10 CFR 50.90
L-2005-247
January 27, 2006

Re: Turkey Point Units 3 and 4
Docket Nos. 50-250 and 50-251
License Amendment Request No. 178
Spent Fuel Pool Boraflex Remedy

License Amendment Request No. 178

FIGURE 5.5-3

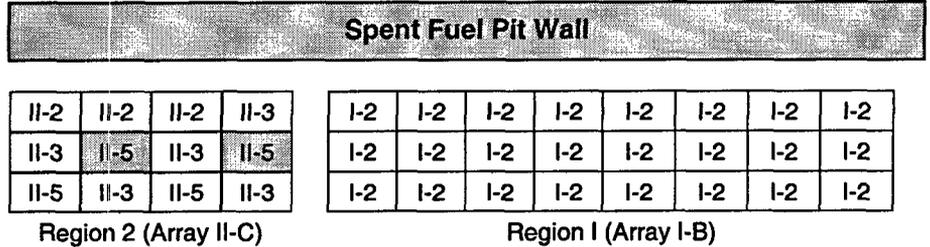
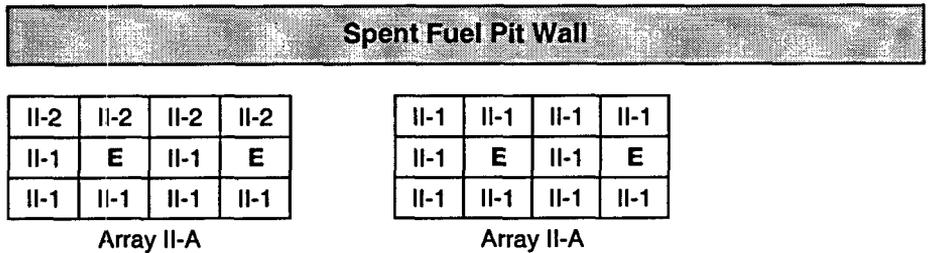
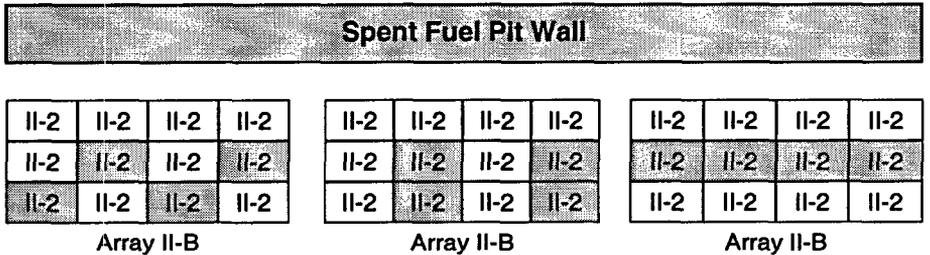
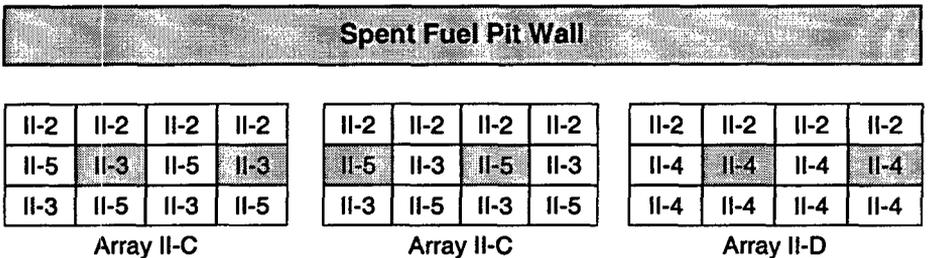
5.5.1.3.c is added to restrict the Region II storage configurations that may be placed next to Region I racks to those that meet the requirements of Figure 5.5-3.

Figure 5.5-3 is added to describe allowable interfaces between Region II and Region I storage arrays. Justification: The revised spent fuel storage configurations align with the criticality analyses described in this evaluation and in Attachment 9.

An assembly of rank II-2 placed in the peripheral row of a Region II storage rack shall not be adjacent to a Region I storage rack.

For Array II-A, the empty cell in the 2x2 II-A array shall be adjacent to the peripheral row that contains the category II-2 assembly(s). For Array II-A only, the peripheral row may contain category II-1 assemblies as the outer two rows will comply with Array II-A requirements.

For Array II-B, the Metamic insert (or full length RCCA in the assembly) shall be adjacent to the peripheral row that contains the category II-2 assembly(s).

For Arrays II-C and II-D, the Metamic insert (or full length RCCA in the assembly) shall be adjacent to the peripheral row that contains the category II-2 assembly(s).
